CERTIFICATE OF APPROPRIATENESS

Property: 802 Arlington Street, Tracts 13A & 14A, Block 250, Houston Heights Subdivision. The property includes a historic 2,210 square foot 1½-story wood frame single family residence and attached garage situated on an 8,200 square foot (100' x 82') corner lot.

Proposal: Alteration – Revision. Alter the non-original front dormer window to meet egress requirements. The existing dormer features a non-operable divided arch window. The dormer will be extended forward and a single wood casement window will be installed.

HAHC Action: Approved

WEST ELEVATION – FRONT FACING ARLINGTON STREET

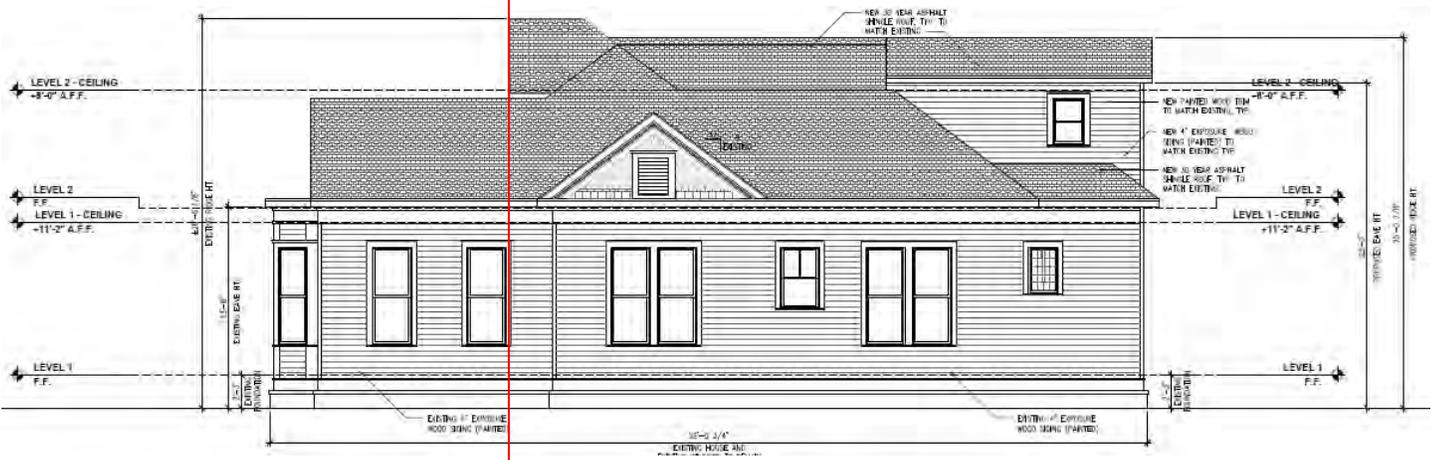
Front Elevation: The existing and previously approved non-original dormer features a divided-lite arch fixed window tucked into the roof. The ridge of the dormer extends past the ridge of the main roof.

In the proposal, the dormer will extend forward. Due to the dormer extending forward, more siding will become visible. The arch window removed and replaced with a larger casement window. See drawings for more detail.

The proposed replacement of the existing dormer, which may not be original to the structure, is acceptable in that the design elements of the proposed dormer are more in character with other design elements on contributing structures in the historic district.

SOUTH SIDE ELEVATION
EXISTING

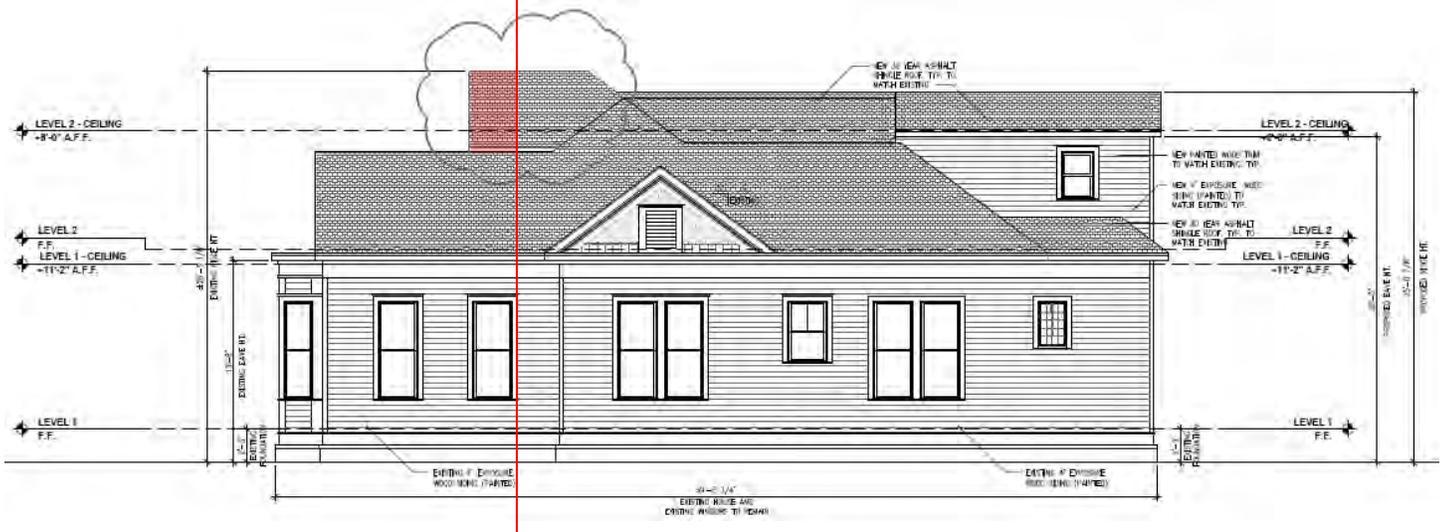
Side Elevation: In the proposal, the side profile of the dormer will extend 3'-3" forward (to the west). See drawings for more detail

NORTH SIDE ELEVATION
EXISTING

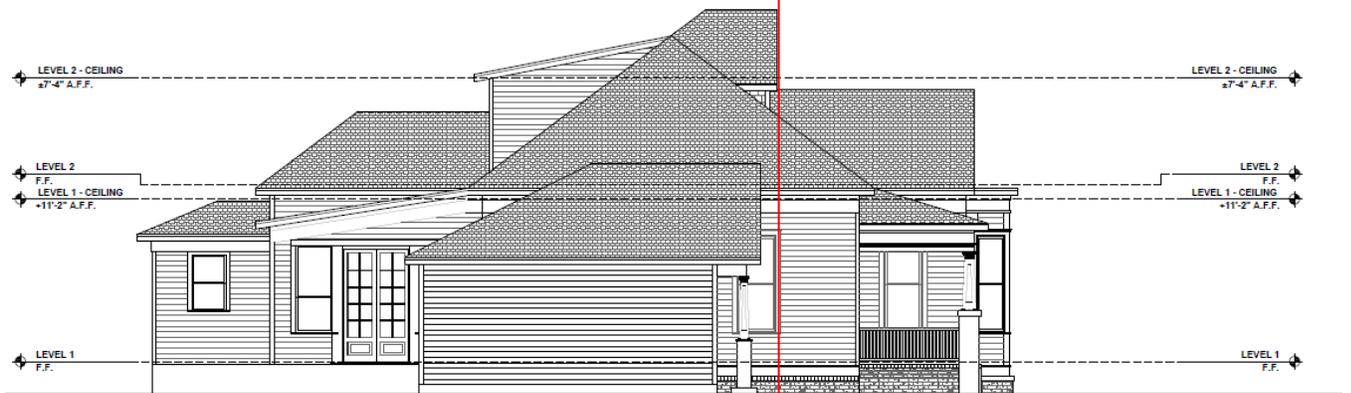
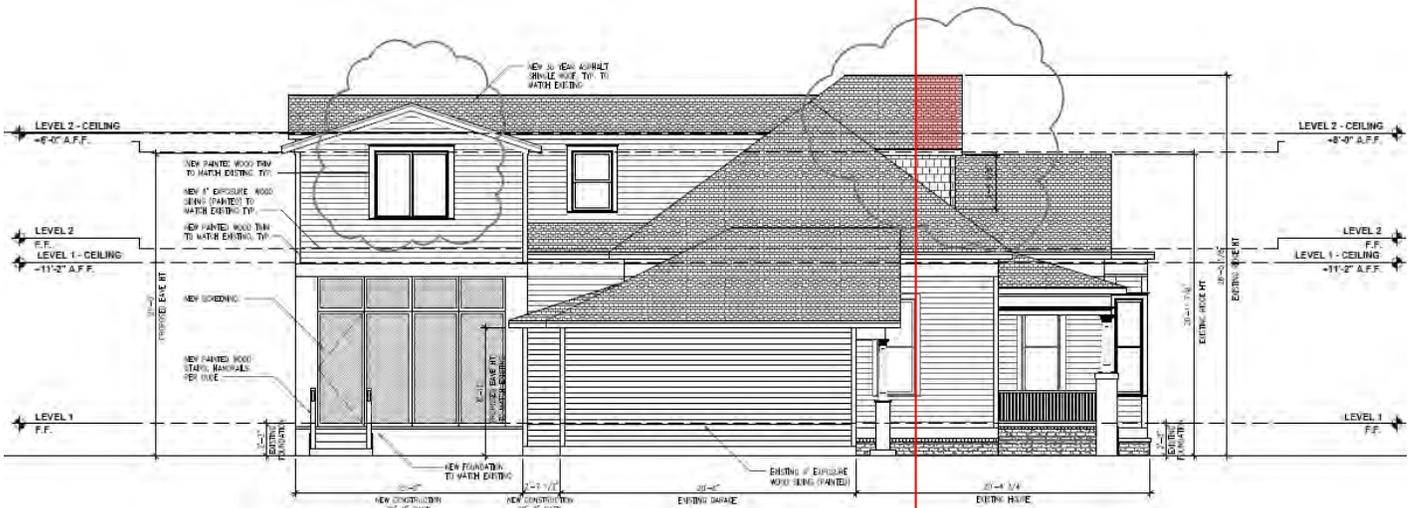
Side Elevation: In the proposal, the side profile of the dormer will extend 3'-3" forward (to the west). A pair of double hung windows at the rear will be replaced with casement windows. See drawings for more detail
